REMARKS

The Invention

FIG. 14
(PRIOR ART)

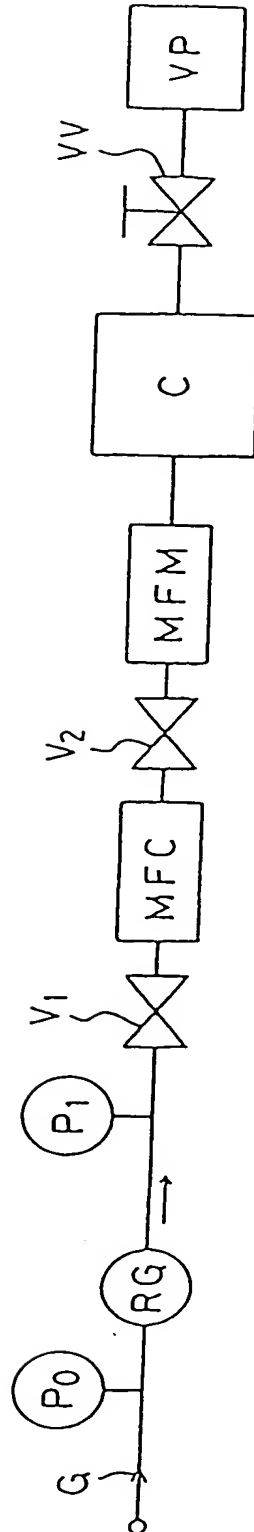
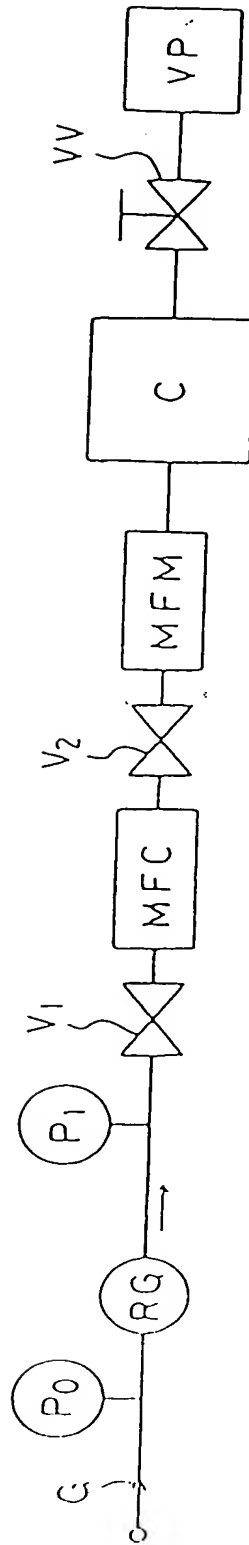
With the above amendments, the specification has been amended to incorporate the parent and grandparent applications by reference. The abstract has been amended to comply with 37 C.F.R. § 1.72. The Figures 14-18 have been amended to include the designation “Prior Art.”

FIG. 15
(PRIOR ART)

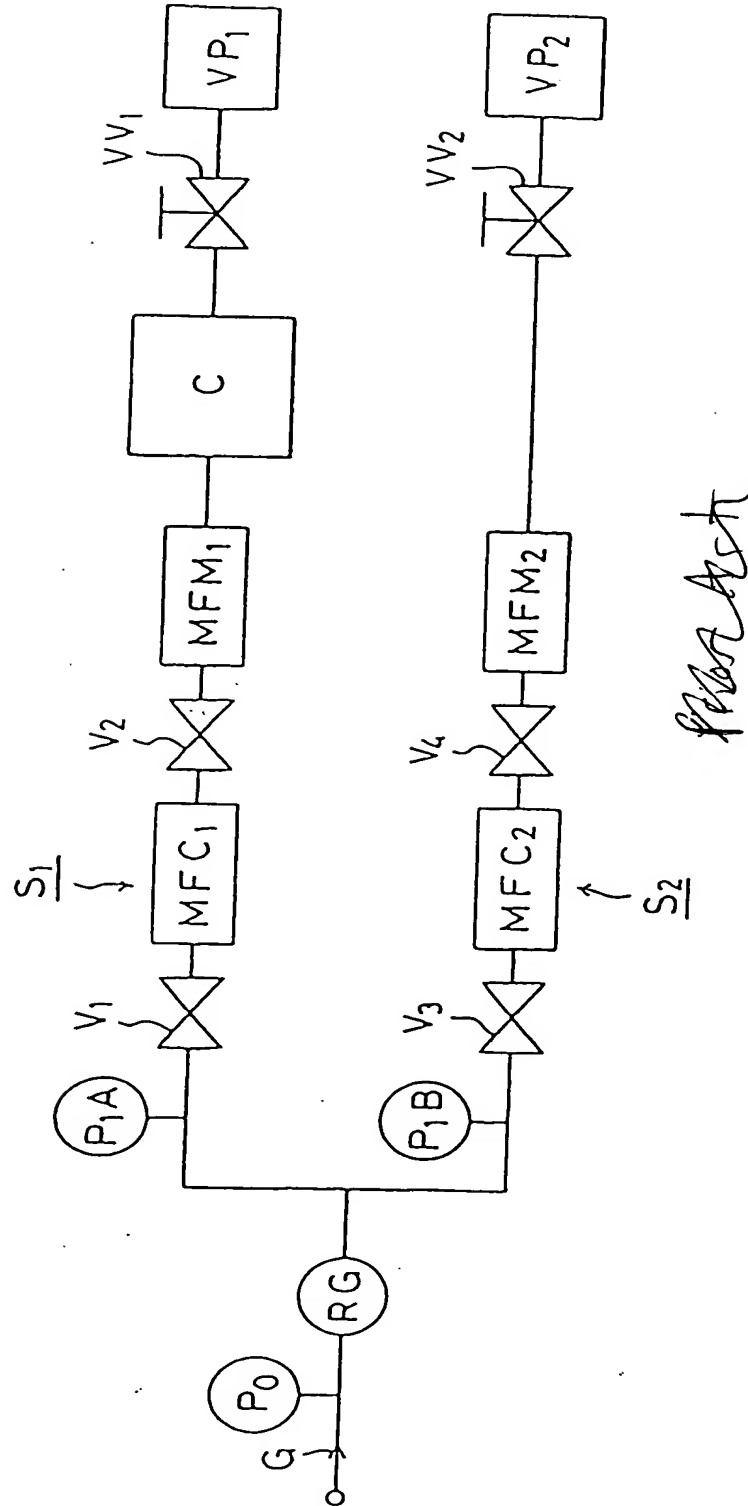
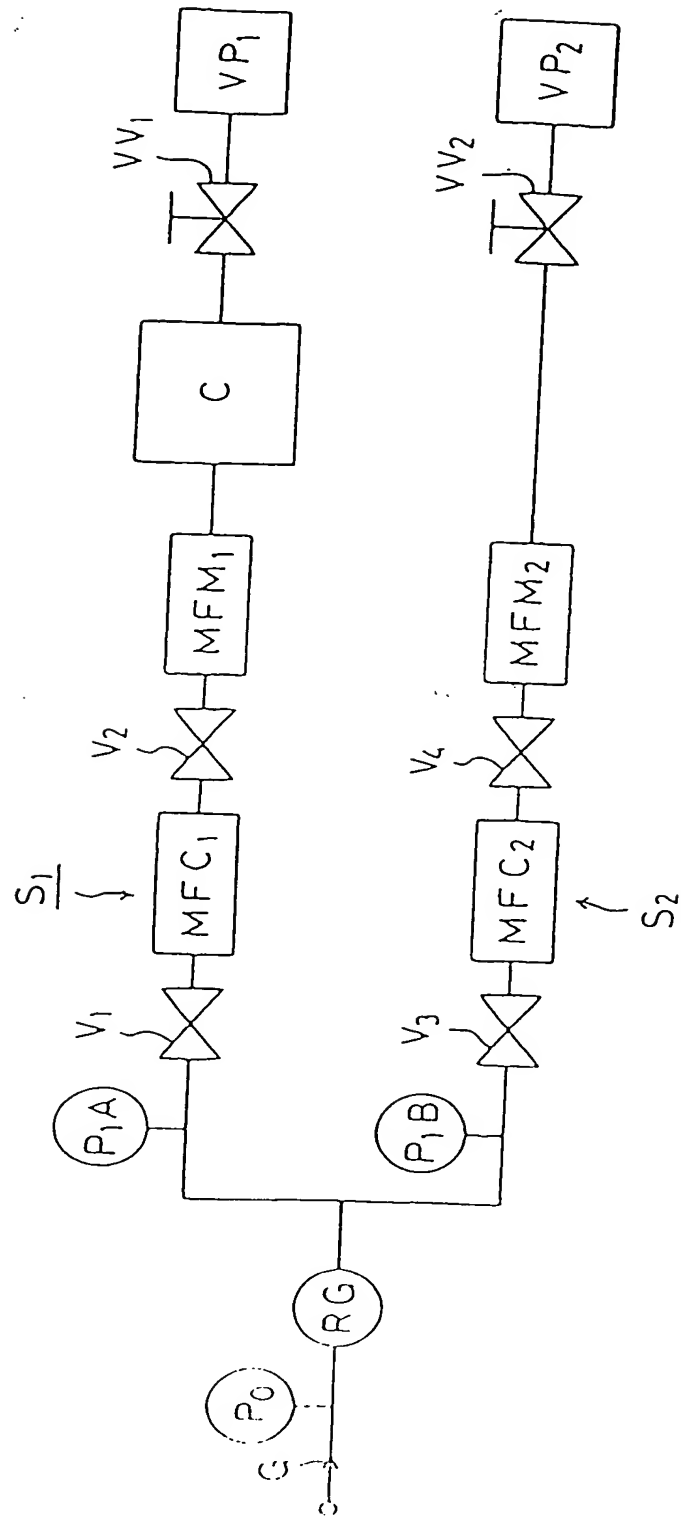
Figure 15 of the present application schematically illustrates a prior art two flow passage fluid supply apparatus (see page 17, lines 19-10, of the present application).

However, the apparatus shown in Figure 15 is plagued by undesirable transient signal surges as shown in Figure 16 when valves V_3 and V_4 are opened (i.e., switched from a closed to an open state). Applicants studied the apparatus shown in Figure 15 and determined that when the mass flow controller MFC_2 is opened quickly to reach the set flow rate level, a large quantity of material gas suddenly flows into flow passage S_2 , which causes the pressure P_{1A} to drop transiently and cause the signal MFC_1 and MFM_1 to undergo a transient change as well (see instant specification, page 9, lines 3-7).

FIG. 16.
(PRIOR ART)

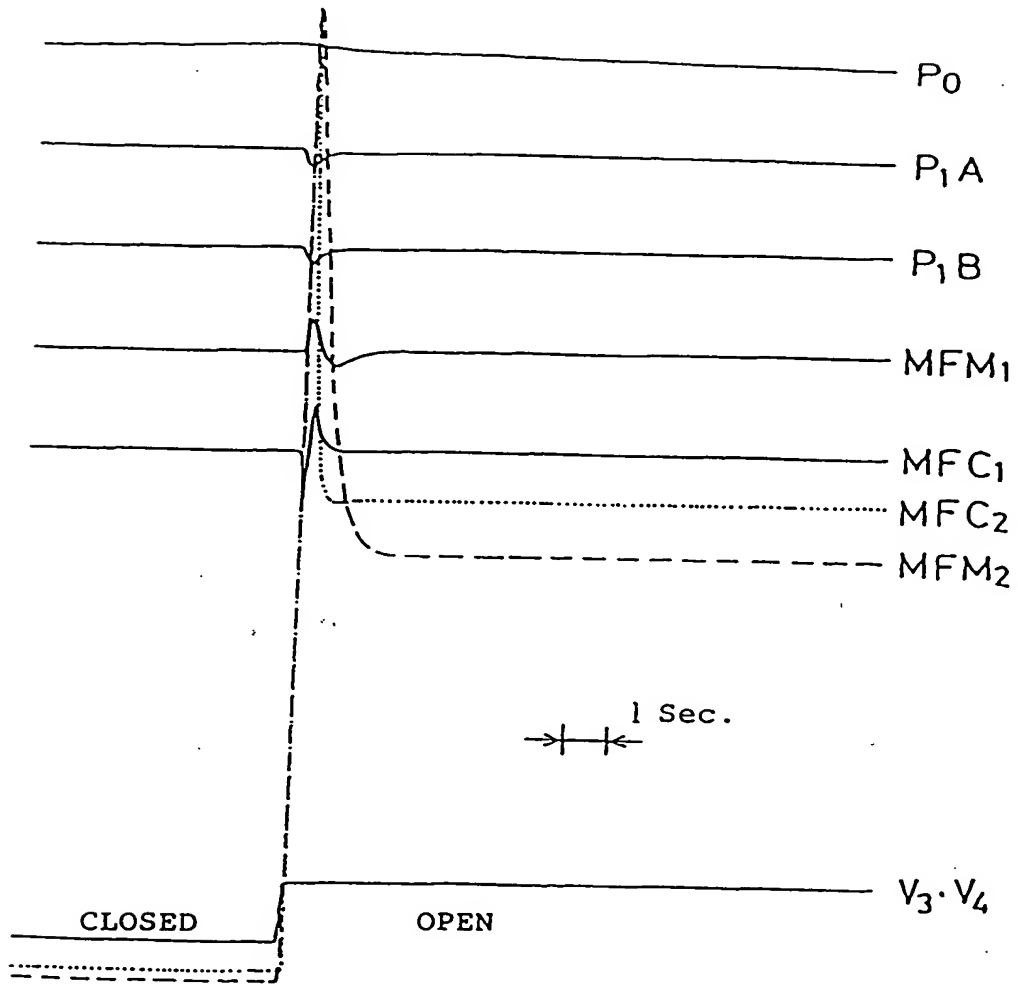
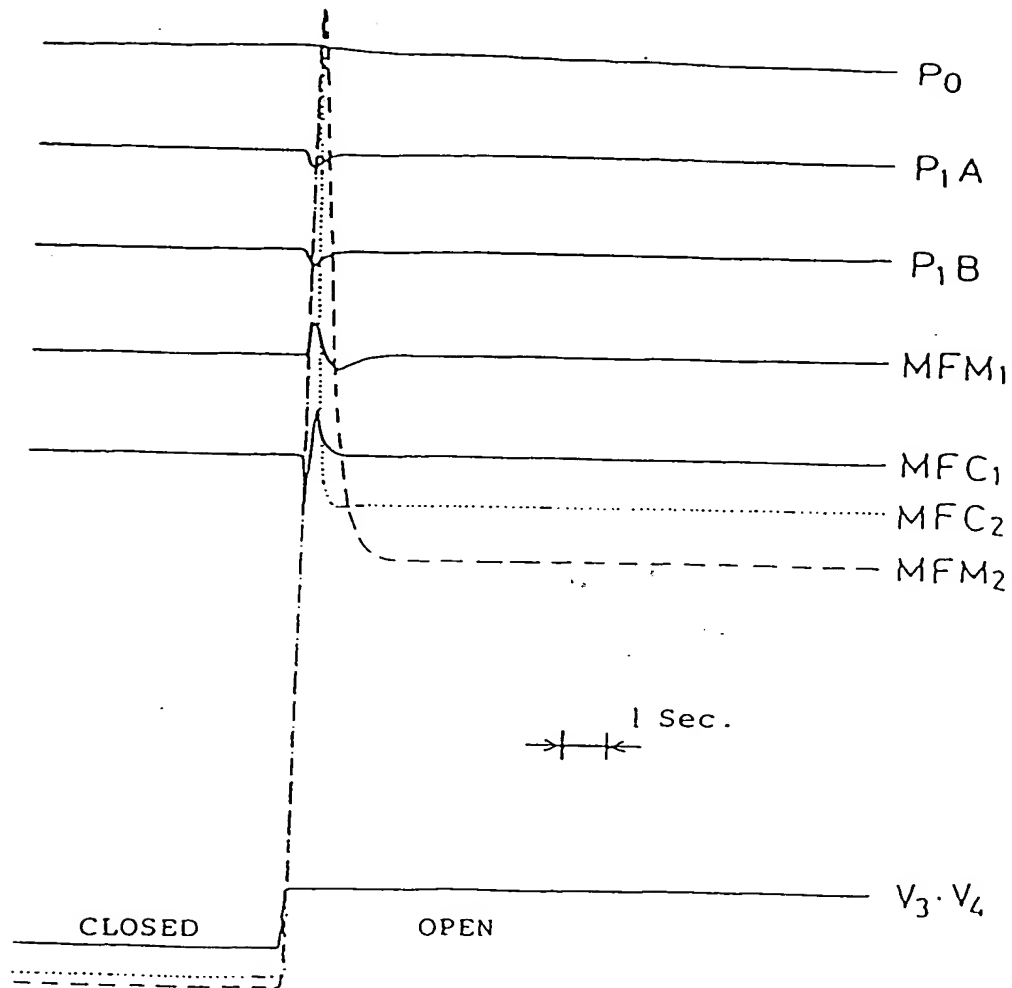
In the present case, Applicants discuss the three prong Soni test as follows. With respect to the first prong of the test, Figure 16 of the instant application demonstrates transient surge effects in the various portions (i.e., P_1A , P_1B , MFM_1 , MFC_1 , MFC_2 , and MFM_2) of the prior art apparatus shown in Figure 15 when a mass flow controller MFC_2 is used to open one closed flow passage while the other flow passage is open. The apparatus shown in Figure 15 is the closest prior art to the presently claimed invention of claim 4. Applicants are only required to compare the claimed invention to the closest prior art in order to overcome an obviousness determination. In re Burkel, 201 U.S.P.Q. 67, 71 (C.C.P.A. 1979).

In addition, the apparatus claimed in claim 4 has the unexpected property of being free of transient surge effect. As shown in Figure 16, the signals in MFC_2 and MFM_2 of the prior art apparatus demonstrate massive amounts of perturbation and are not approximately square. On the other hand, as shown in Figure 9, the signals in FCS_2 and MFM_2 of the apparatus recited in claim 4 are approximately square and demonstrate no transient surge effect.
